ATTACHMENT 2
TECHNICAL SPECIFICATIONS/BASES CHANGES

9502130113 950130
PDR ADOCK 05000269
P PDR

Table 3.8-1

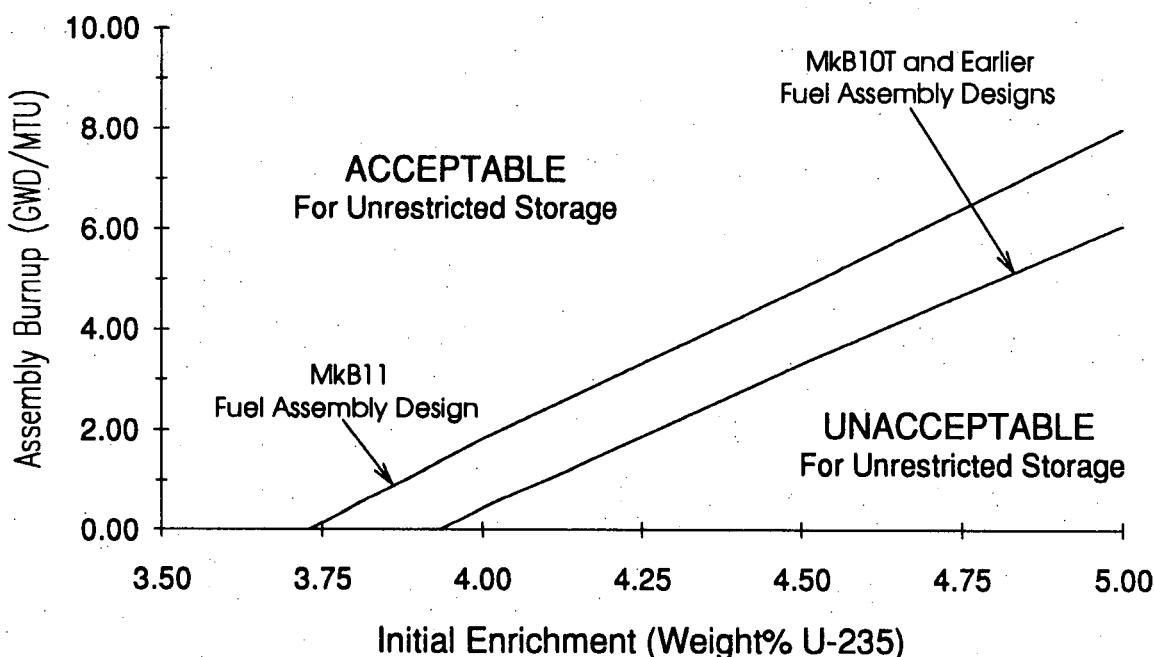
Minimum Qualifying Burnup Versus Initial Enrichment
for Unrestricted Storage in the Unit 1 and 2 Spent Fuel Pool

Fuel which does not meet the requirements of Table 3.8-1 may be qualified for Unrestricted storage by means of an analysis using NRC approved methodology to assure that k_{eff} is less than or equal to 0.95.

Likewise, previously unanalyzed fuel up to 5.0 weight% U-235 may be qualified for Restricted storage by means of an analysis using NRC approved methodology to assure that k_{eff} is less than or equal to 0.95.

Table 3.8-2

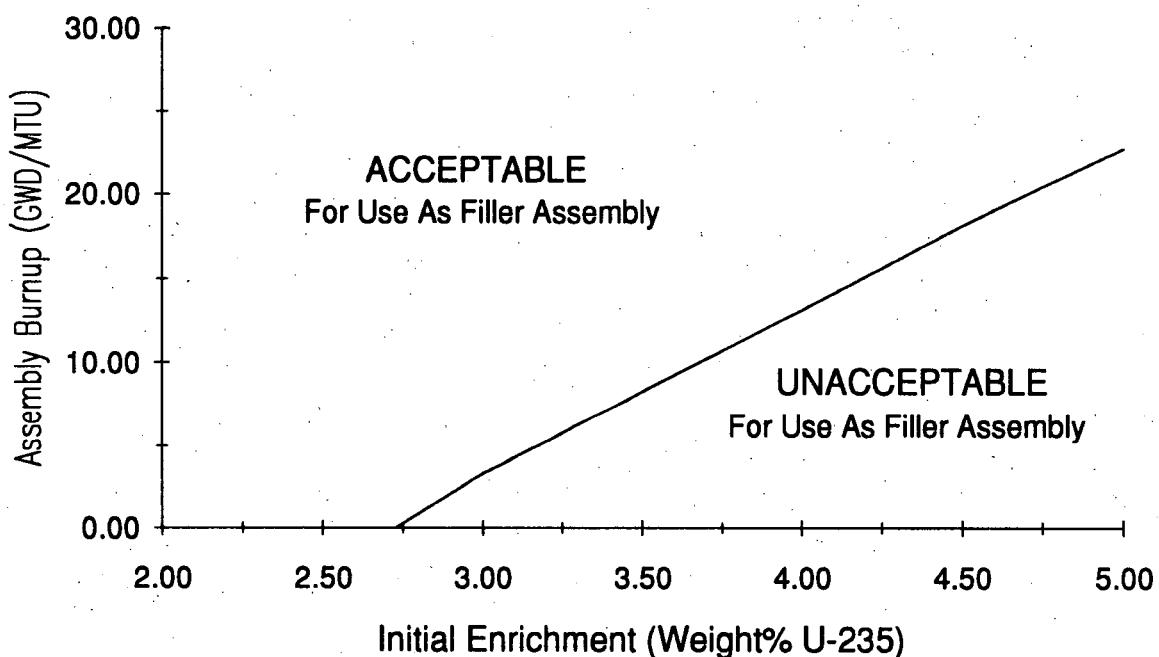
Minimum Qualifying Burnup Versus Initial Enrichment
for Filler Assemblies in the Unit 1 and 2 Spent Fuel Pool

Fuel which does not meet the requirements of Table 3.8-2 may be qualified for use as a Filler Assembly by means of an analysis using NRC approved methodology to assure that k_{eff} is less than or equal to 0.95.

Table 3.8-3

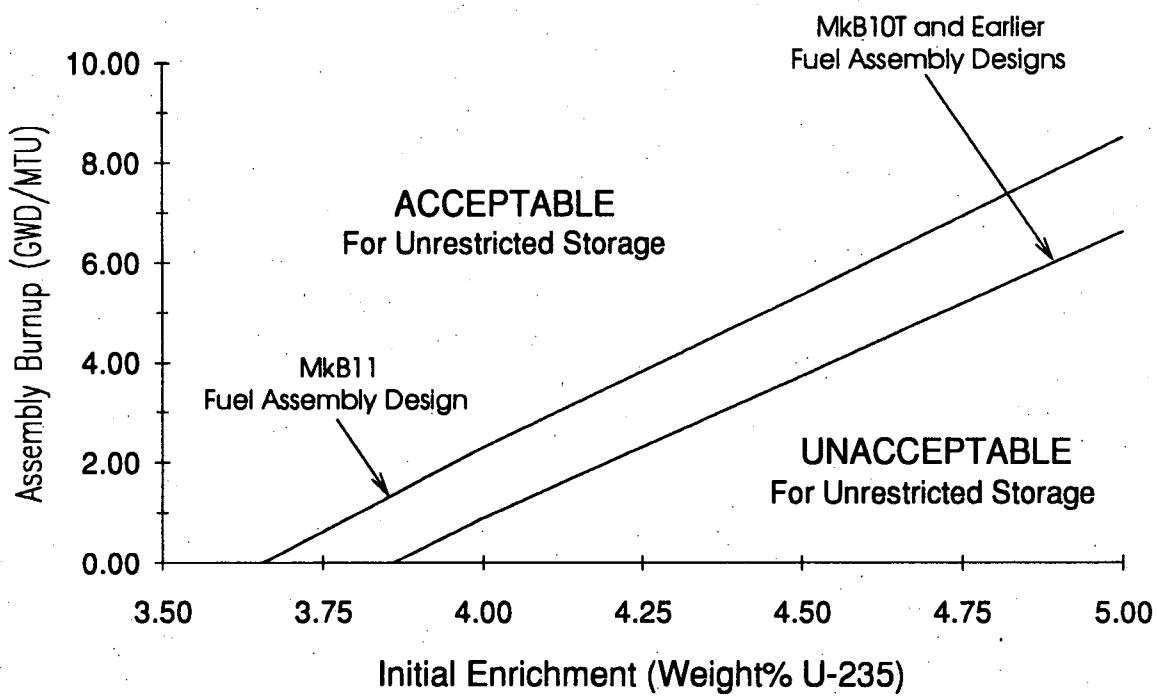
Minimum Qualifying Burnup Versus Initial Enrichment
for Unrestricted Storage in the Unit 3 Spent Fuel Pool

Fuel which does not meet the requirements of Table 3.8-3 may be qualified for Unrestricted storage by means of an analysis using NRC approved methodology to assure that k_{eff} is less than or equal to 0.95.

Likewise, previously unanalyzed fuel up to 5.0 weight% U-235 may be qualified for Restricted storage by means of an analysis using NRC approved methodology to assure that k_{eff} is less than or equal to 0.95.

Table 3.8-4

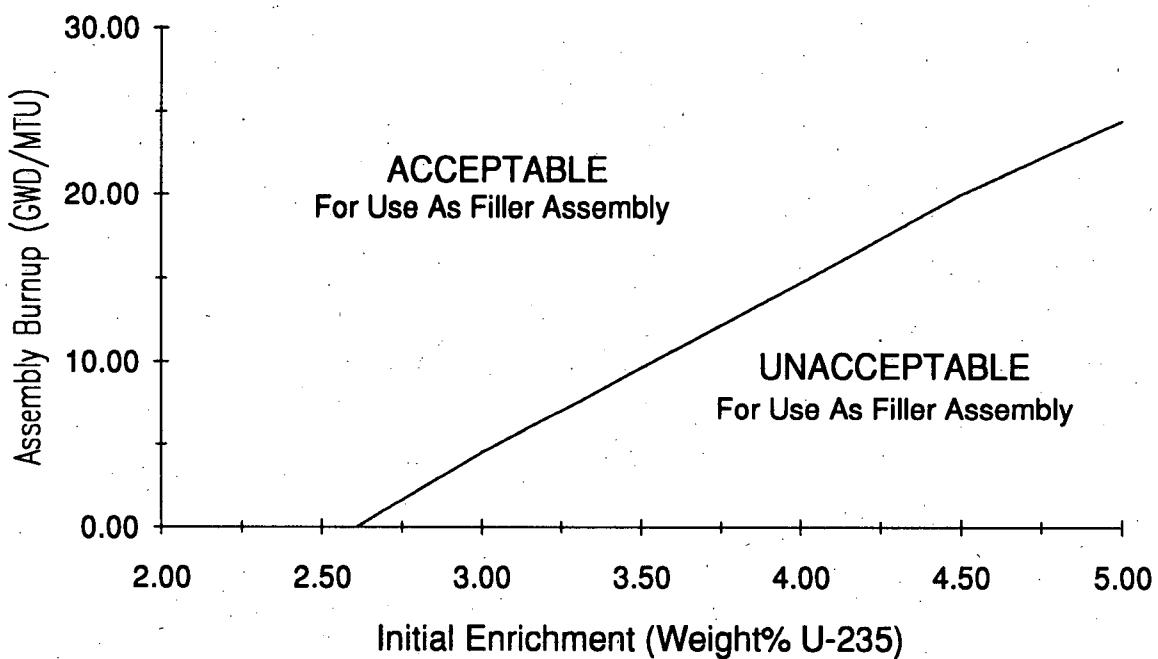
Minimum Qualifying Burnup Versus Initial Enrichment
for Filler Assemblies in the Unit 3 Spent Fuel Pool

Fuel which does not meet the requirements of Table 3.8-4 may be qualified for use as a Filler Assembly by means of an analysis using NRC approved methodology to assure that k_{eff} is less than or equal to 0.95.
